July 30, 2025

PROJECT NAME: PINE VILLAGE MANUFACTURED HOME PARK

APPLICATION: MAJOR SITE PLAN #32898

PINE VILLAGE MANUFACTURED HOME PARK  
PARCEL 3726-011-001  
MARION COUNTY, FLORIDA  
**POND PV-1 SECTION AND DETAIL**

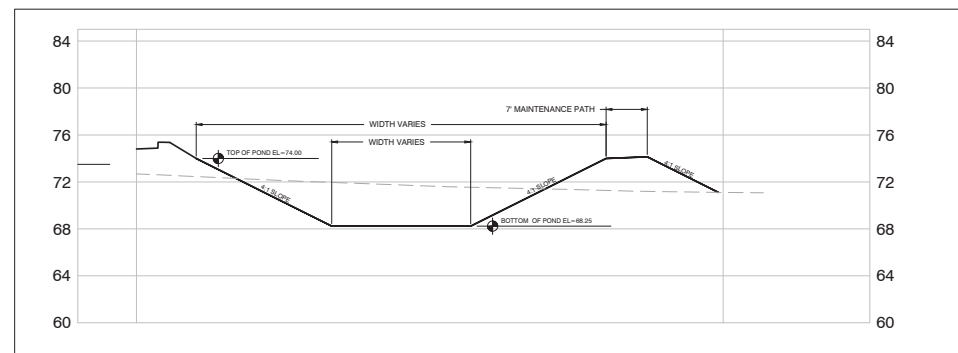
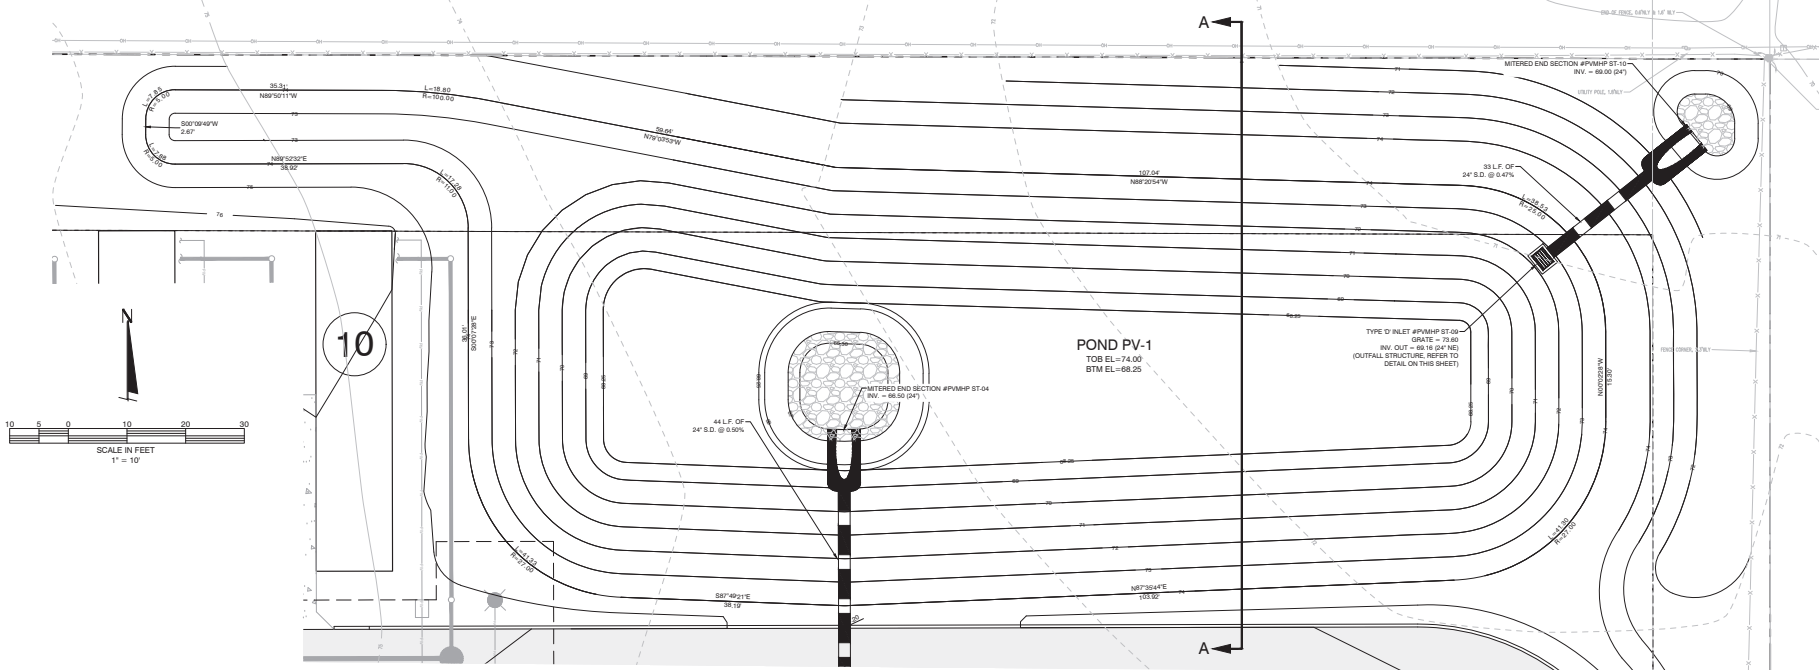
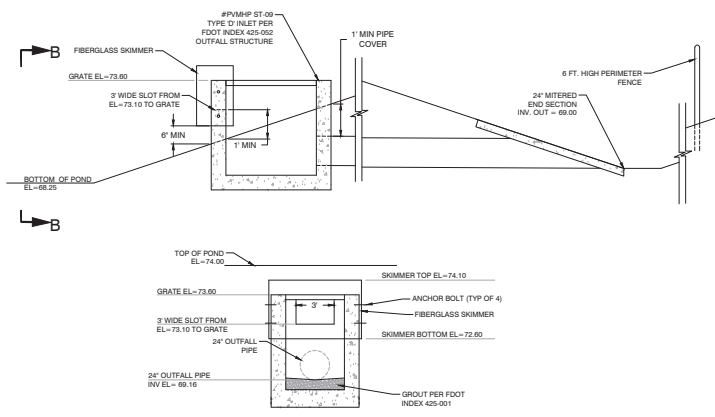
REMARKS: (1) Please update DRA cross section to include the design high water elevation, estimated seasonal high-water elevation, sod stabilization of the pond side slopes, and appropriate vegetative cover on the pond bottom. (2) Please add the following note with the pond cross section: "A minimum of three feet of unconsolidated soil material shall be provided between the surface of any limestone bedrock and the bottom and sides of any stormwater facility." (3) Add coordinates or dimensions to the major pond components (changes in alignment, corners, etc) for constructability.

REMARKS: Retention/detention areas serving commercial lots shall be designed with a minimum berm width of 5 feet stabilized at a maximum of six percent grade maximum around the entire perimeter of the facility.

- 36 DEPARTMENT: ENGDRN - STORMWATER REVIEW  
REVIEW ITEM: 6.13.6 - Stormwater Quality Criteria  
STATUS OF REVIEW: NO  
REMARKS: Please indicate the proposed DRA stabilization method on the DRA cross section. DRAs greater than 4' deep require the bottom to be sodded in addition to the side slopes.

PINE VILLAGES MANUFACTURED HOME PARK  
MARION COUNTY, FLORIDA  
PHOTOMETRIC PLAN

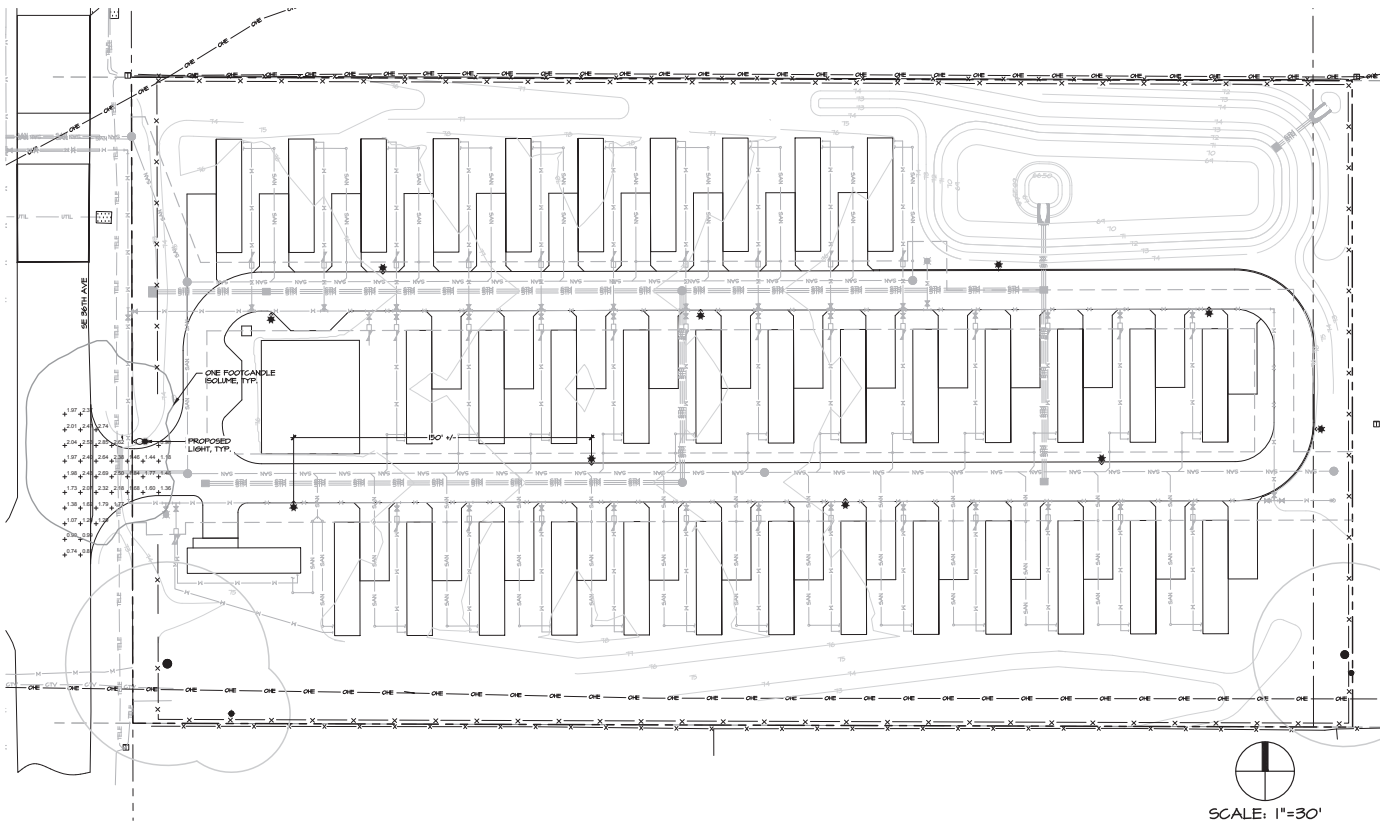
- 60 DEPARTMENT: LSCAPE - LANDSCAPE DESIGN AND IRRIGATION  
REVIEW ITEM: 6.19.3 - Outdoor lighting plan requirements  
STATUS OF REVIEW: NO  
REMARKS: 1. Light at entry appears to have light spillage onto adjacent street, please adjust to reduce glare and spillage. (6.19.6.A)
